**Public Utilities
Commission of Ohio**

To: Docketing Division
From: George Martin, Grade Crossing Planner, Rail Division
Re: PUCO Case No. 12-2198-RR-RCP
Date: August 29, 2012

On July 30, 2012, Norfolk Southern Railway (NS) filed in this docket a request to temporarily downgrade the existing warning devices at State Street, DOT# 473711A, in Fremont, Sandusky County. Specifically, NS requested that it be allowed to remove the cantilever that existed in the northeast quadrant of the crossing.

Diagnostic Review Team Survey

Field Dimensions

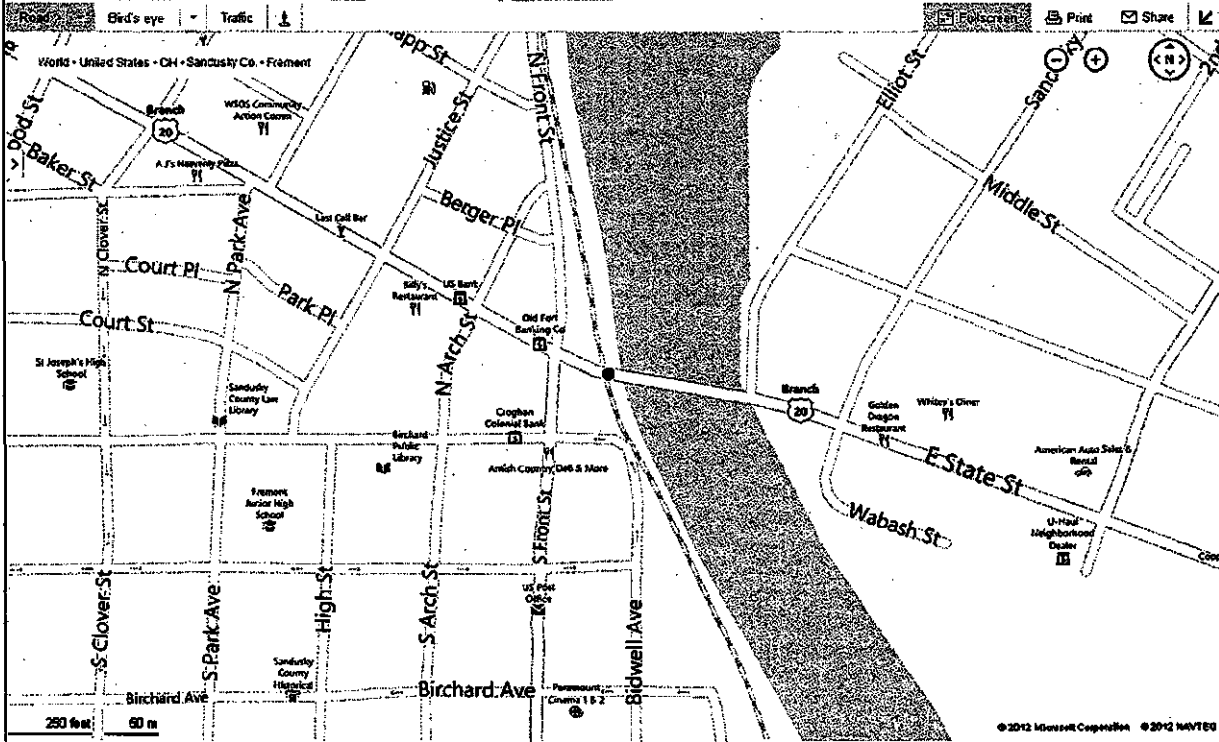
Diagnostic Team Recommendations

Quadrants Needed
☒ Install/upgrade active devices	
☐ Automatic Flashing Lights (AFLS)	
☒ AFLS / Cants	
☐ AFLS / Gates	
☒ AFLS / Gates / Cants	
☒ Bells / number	2
☒ Upgrade circuitry / type	
☐ Sidelights	
☐ Guardrail Needed	
☐ Install/Replace curb	
☒ Bungalow placement & offset from rail & highway	North West Quad
☐ Other (define)

No First Responders pre

interconnect affects adjacent Highway Intersect. Crossing (4)

- ☒ Install/upgrade traffic signal preemption
- ☐ No improvements needed
- ☐ Other (define)
